**STAFF REPORT FOR THE HISTORIC RESOURCES COMMISSION
MEETING OF DECEMBER 11, 2014**

FILE NO.: HRC-14-146

REQUEST: To consider a request from property owner Herman Bauer to amend a previously approved Historic Resources Commission application, HRC-10-102 and HRC-10-102(A), to allow for modification of the buildings and site to accommodate additional dwelling units on property zoned Residential Office (RO), located at 812 N. Division Street, APN 001-191-06.

LOCATION: 812 N. Division Street

LANDSCAPE PLAN

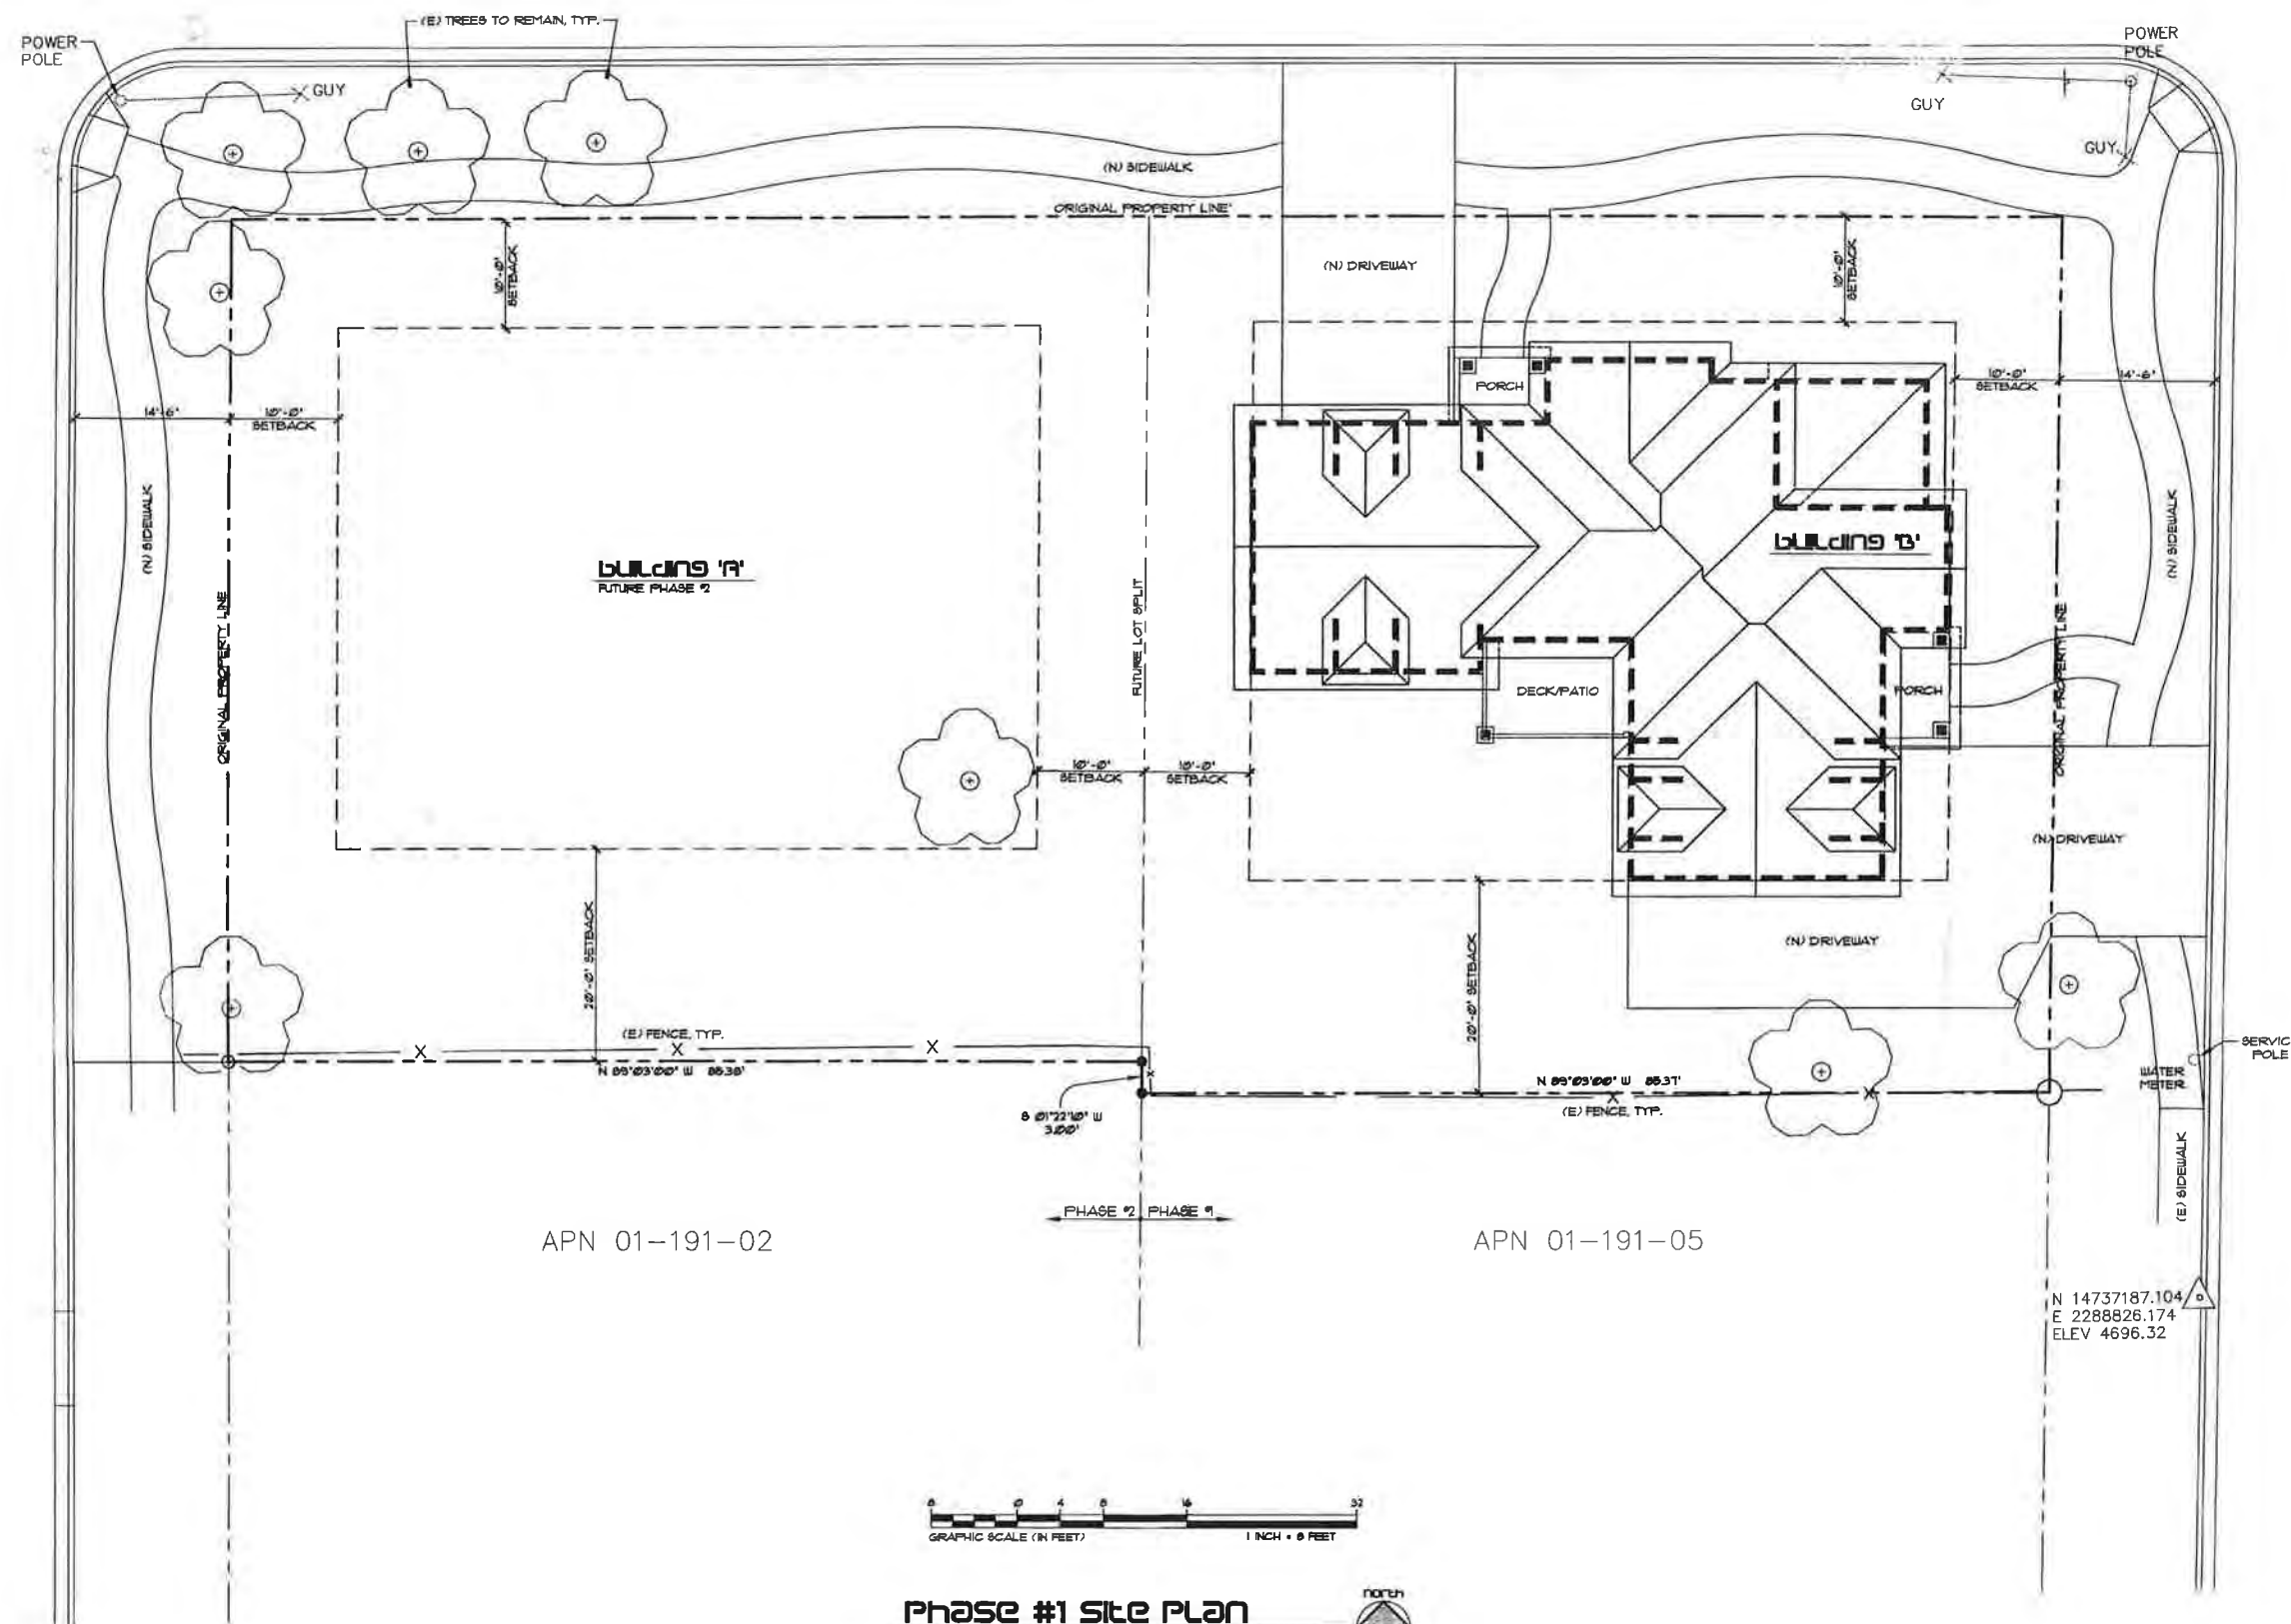
- Additional walkways to the rear lawn areas are proposed from the Ann Street driveways.
- The approved chokecherry and crabapple trees have been removed from the landscape plan.

- The approved spiraea has been replaced with lavender in the proposed landscape plan.
- The approved lilac has been replaced with sea green juniper in the proposed landscape plan.

- Approximately 11 trees per building are currently proposed, in comparison to the 15 trees per building approved previously (note that the previous approval count is based on landscaping for only one building).

- Approximately 50 shrubs per building are currently proposed, in comparison to the 57 shrubs per building approved previously (note that the previous approval count is based on landscaping for only one building).

11. The applicant shall provide, at a minimum the following new trees and shrubs **per building** as agreed to with the previously approved landscape plan:

- Four – Three inch caliper Sargent Crabapple trees

- Six – Six to Seven foot tall Jeffrey Pine trees
 - Three – Three inch caliper Amur Chokecherry trees
 - Two – Three inch caliper Red Maple trees
 - 11 – Five gallon lilac shrubs instead of sea green juniper shrubs

DRAWING TITLE:
BLDG. 'A'
EXTERIOR
ELEVATIONS

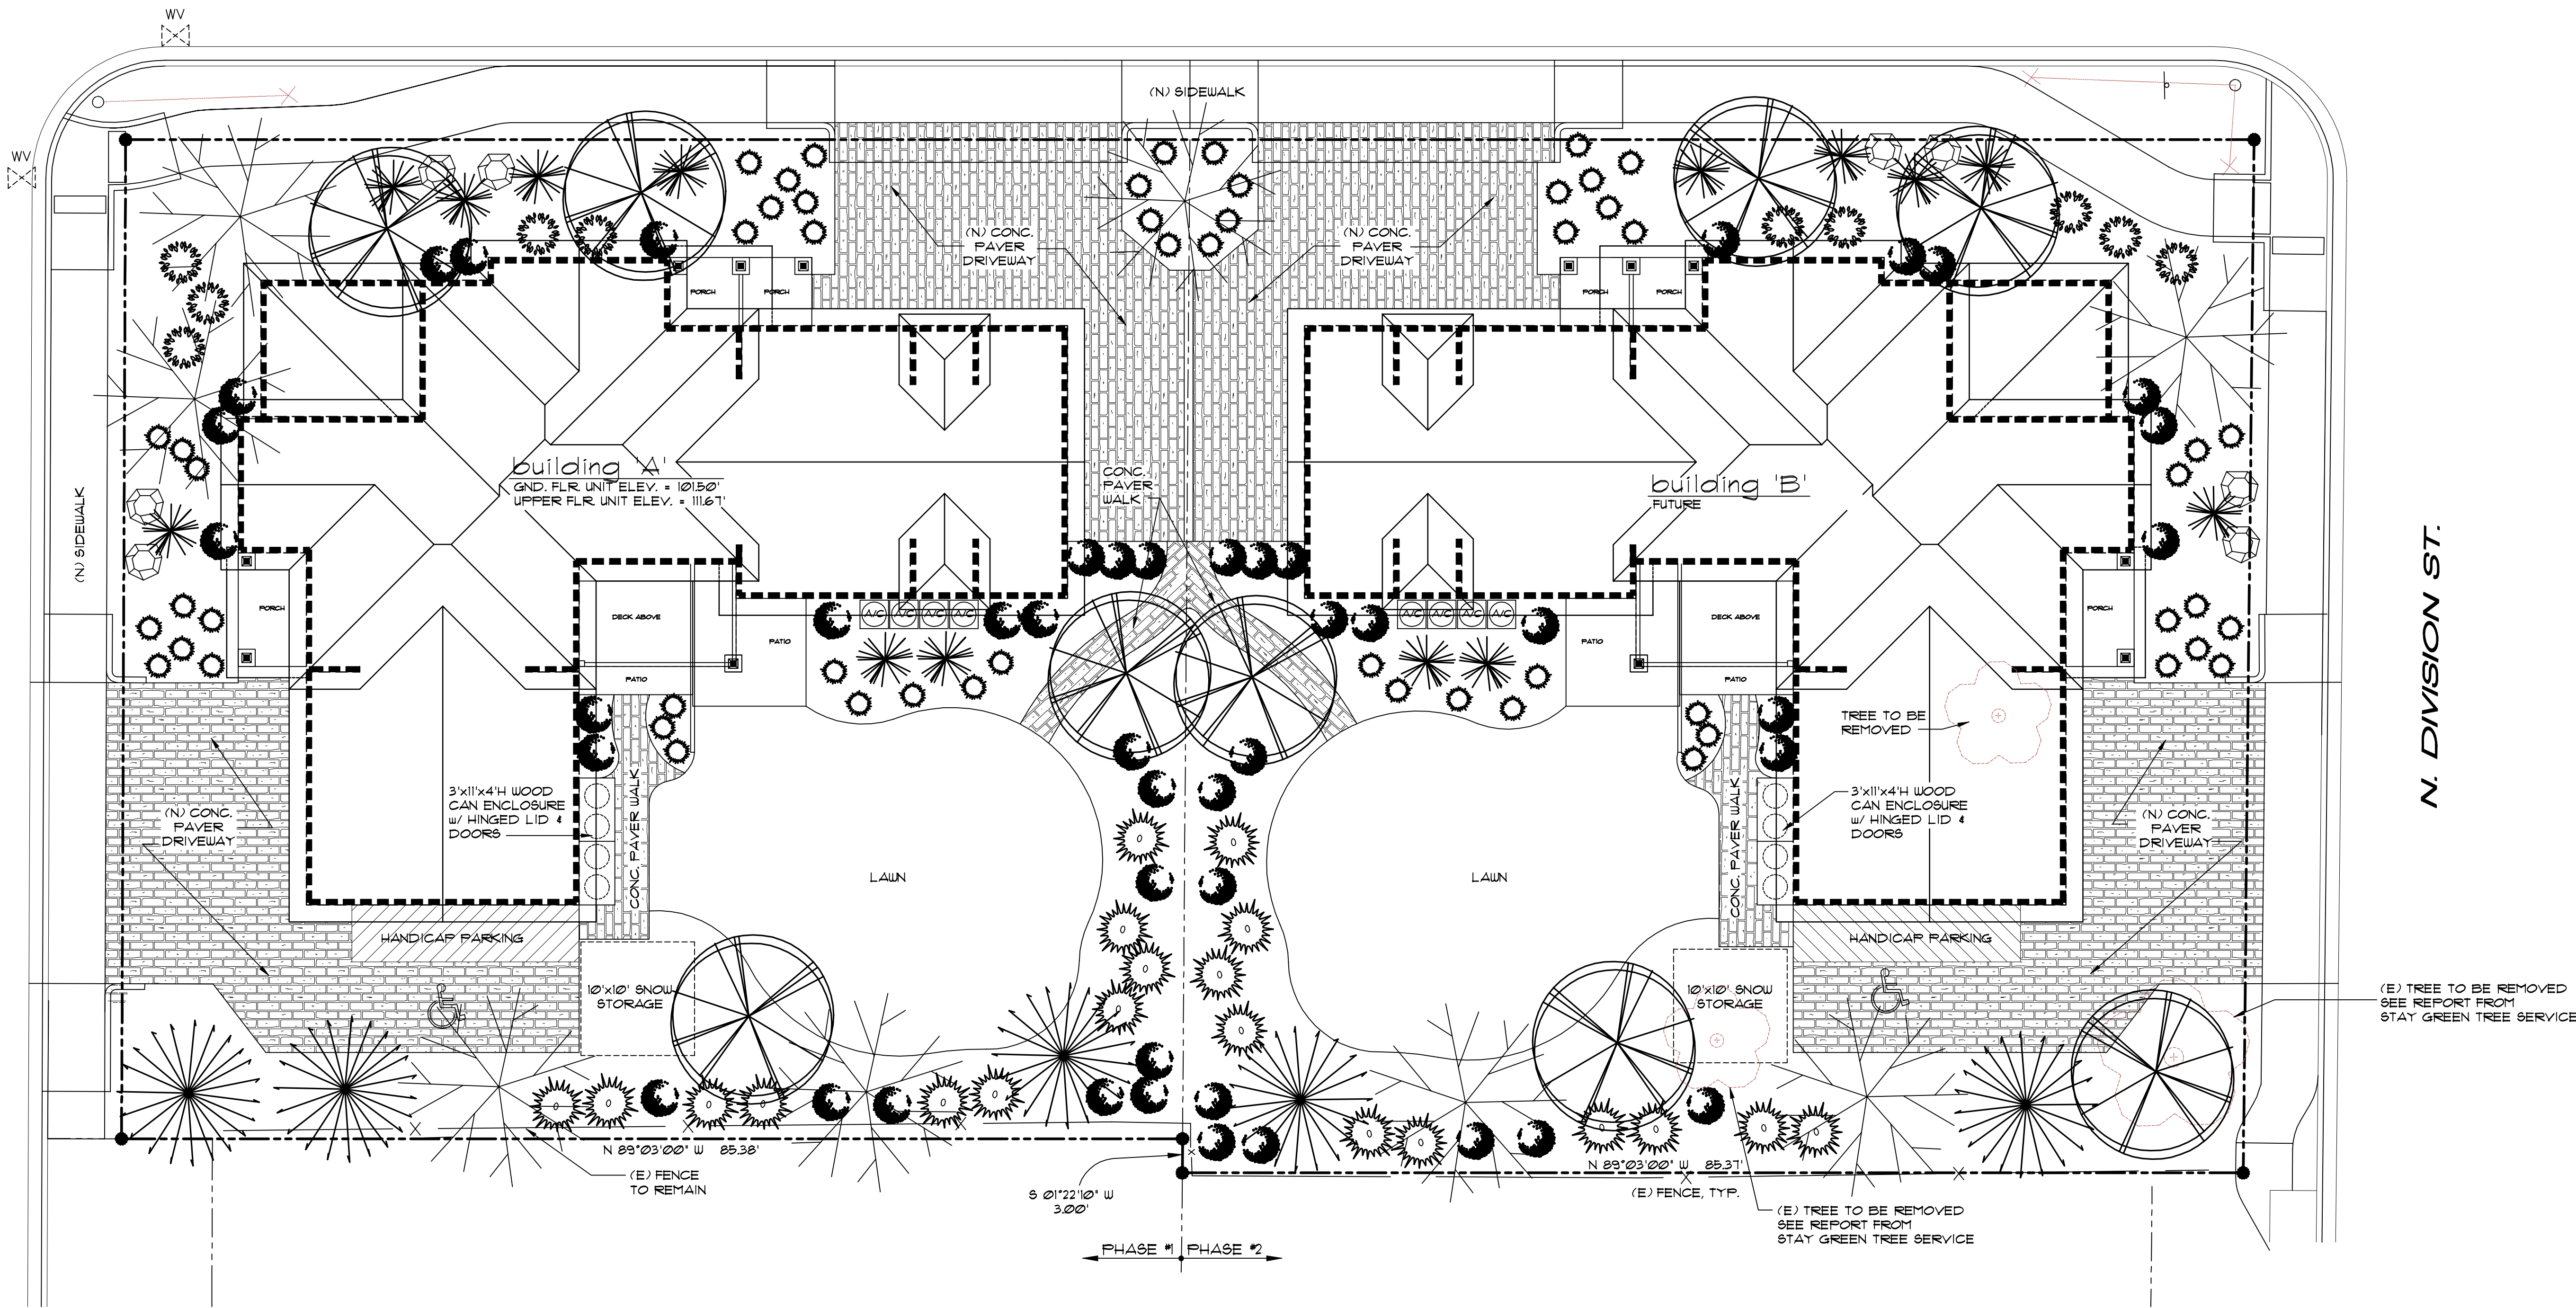
- The rear patio on each structure is slightly larger than previously approved.
- Elevations (For purposes of this approval, the applicant provide elevations for the westernmost most building only. All references to the elevations are based on the westernmost building. The easternmost building is proposed to be a mirror image.):

- North Elevation – Two exterior main entrance doors are proposed instead of one and two porch posts instead of one.
 - East Elevation – No changes proposed.

- South Elevation – One window is proposed instead of two at the patio, and a double door is proposed to the east of the patio.
 - West Elevation – A one-story roofline is proposed at the two-car garage versus a two story roofline in the previous approval, with the elimination of a dormer window. The addition of one window above the porch is proposed as well as the elimination of one exterior main entrance door.
